Traffic and Transportation

In accordance with the MEPA Scope, this chapter directly responds to agency and public review comments within MEPA jurisdiction. Copies of the Secretary's Certificate on the Draft Environmental Impact Report (DEIR) and each comment letter received during the public review period of the DEIR are included in this chapter. This chapter provides responses to those letters.

Table 6-2 Response to Comments

Figure 4.3h
Site Details - South Meadow Brook Park

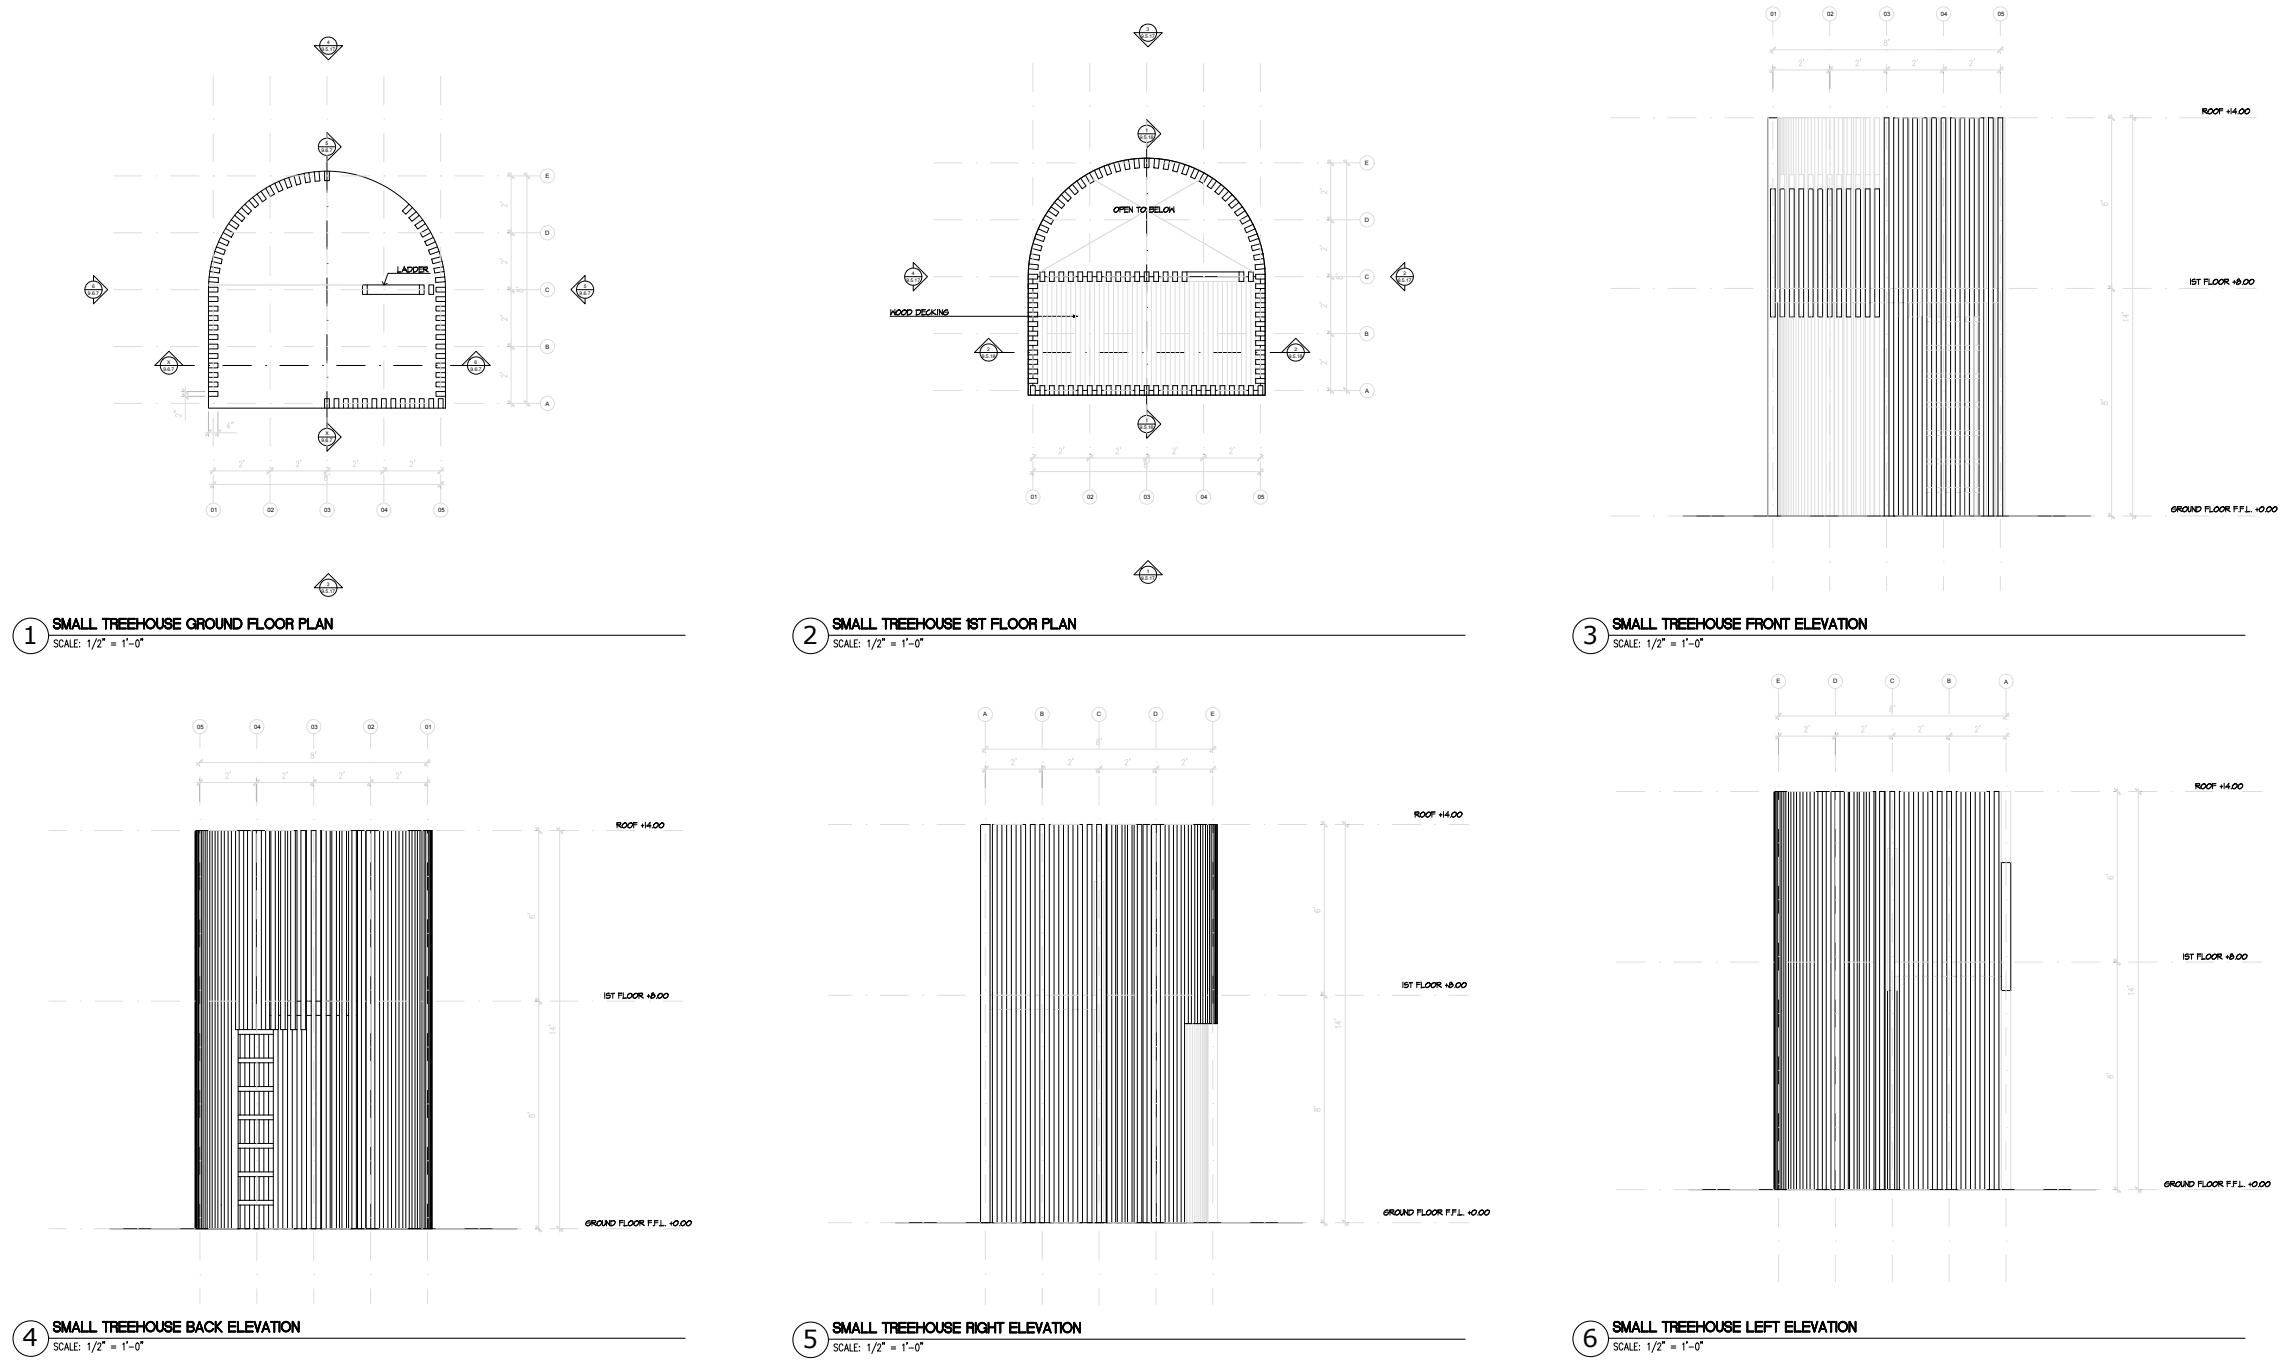
1.35	The FEIR should provide a plan clearly showing all project components within the Riverfront Area, quantify potential impacts to all wetland resource areas and floodplain and describe mitigation measures.	Figures 4.1 - 4.4h provide information on the plantings proposed for the Project and work within the existing daylighted section of South Meadow Brook. No work is proposed within Land Under Waterbodies and Waterways. Refer to Section 4.1 of Chapter 4, <i>Wetlands</i> for more details.

Comment #	Commenter	Comment	Response
5.04 CRWA	<p>Finally, given that the project includes work proposed in the 200 ft. Riverfront Area (RA) of the daylighted section of the South Meadow Brook, the FEIR should contain more details regarding the nature of the work. While the Proponent has committed to improving the RA by reducing the area of pavement and by planting a diverse selection of native trees, shrubs, and other plants, the FEIR should include a much more comprehensive stream restoration plan and supporting details.</p>		<p>Section 4.1 of Chapter 4, <i>Wetlands</i> includes a description the restoration of elements of the South Meadow Brook Riverfront Area. Figures 4.1 - 4.4h provide information on the plantings proposed for the Project and work within the existing daylighted section of South Meadow Brook.</p>
